**Submission on the Wilpinjong Coal Mine MOD 3 - Pit 8 Extension (SSD-6764-Mod-3)**

**Figure 1 Regent Honeyeater sightings (Green Squares) from Munghorn Gap NR and adjoining areas in proximity of approved open cut mining**

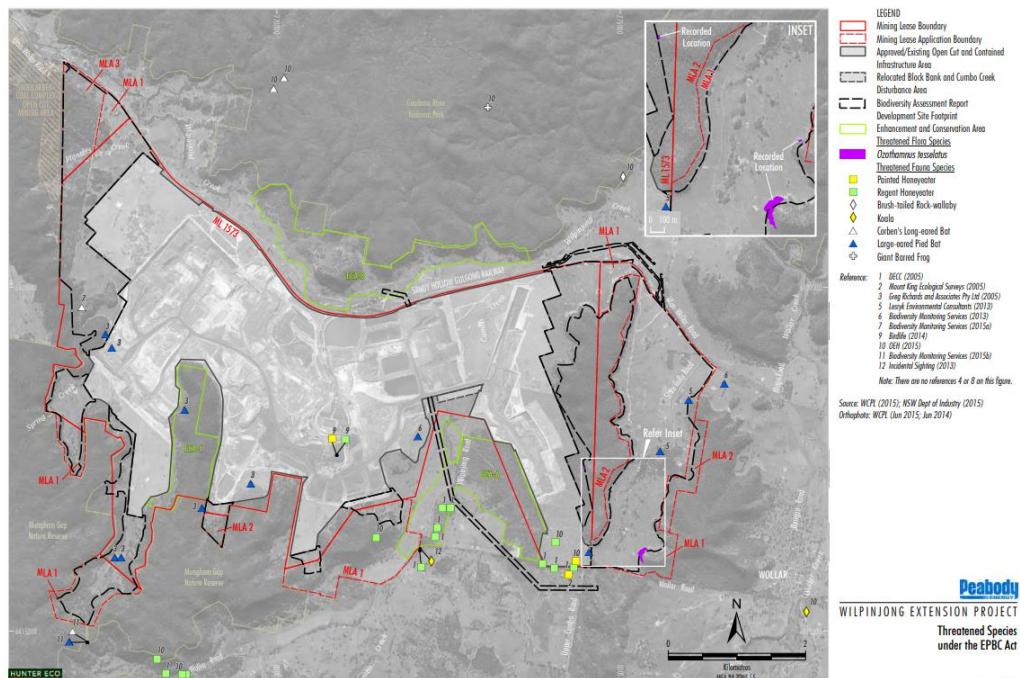
Of particular note the once reliable and regular breeding site for the species at Munghorn Gap NR, (known from Atlas Bionet to have had over 104 separate records of Regent Honeyeater sighting since 1960s) has not had a single known sighting since 2017 and prior to that 2012. The absence of records in this area directly coincides with the approval and commencement of operational mining in close proximity to these habitats (refer to Figure 1 below), including approximately 24 km of shared boundary between this nature reserve and approved open cut mining.

There is a very real probability that this species Important Habitat within the Munghorn NR has indirectly been substantially compromised by successive expansions of the adjoining open cut

mining. These potential indirect impacts and historical contraction in observations and occupied habitats should be further addressed and assessed within the BDAR and SAll assessment.

Figure 2 Pit 8 extension impacts on landscape connectivity and habitat, including loss of important remnant patches of habitat forming stepping stones (Highlighted green)

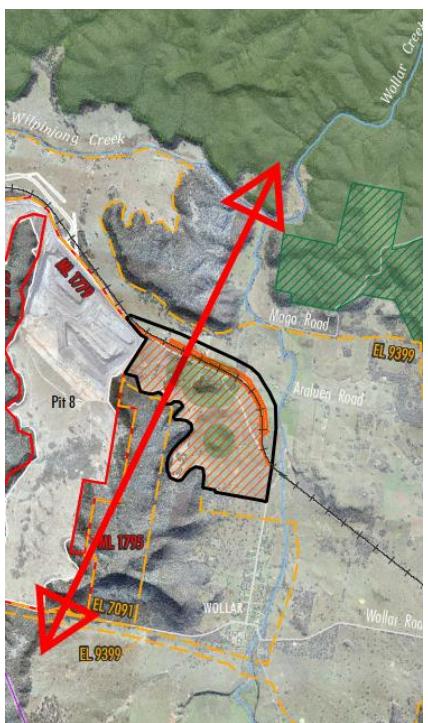
Of note the Mod 8 Extension includes the removal of key stepping stone patches of remnant native vegetation between the GRNP to the north and remnant vegetation connected to the Munghorn Gap Nature Reserve to the south (Refer to Figure 2 below).

These habitats are likely to support a variety of woodland birds including the Critically Endangered Regent honeyeater and mobile fauna like the Endangered Koala.

Importantly this barrier is likely to impact the local movement corridors for recorded populations of Koala including those recorded in the BDARs surveys to the north and regionally significant populations to the south of Wollar
